# Technical Bulletin

## MAP 5000 main panels

### Downgrade

**Oct 28, 2022**

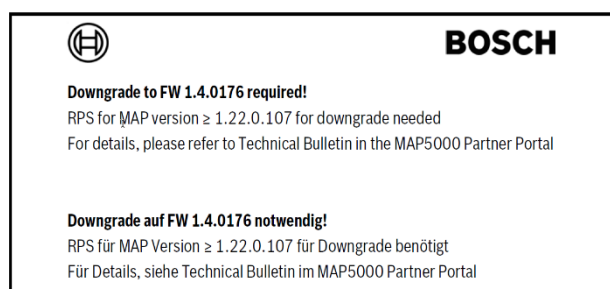
ICP-MAP5000 main panels with firmware version 1.4.0204 or 1.4.0212 must be downgraded.

Additional label with Downgrade information on affected products, will be placed on the box:

To prevent bricked panels, you must downgrade the main panels to firmware version **1.4.0176** before initial installation.

- Use RPS for MAP version 1.22.0.107 or higher for downgrading.
- Download RPS for MAP from MAP5000 Certified Partner Portal.
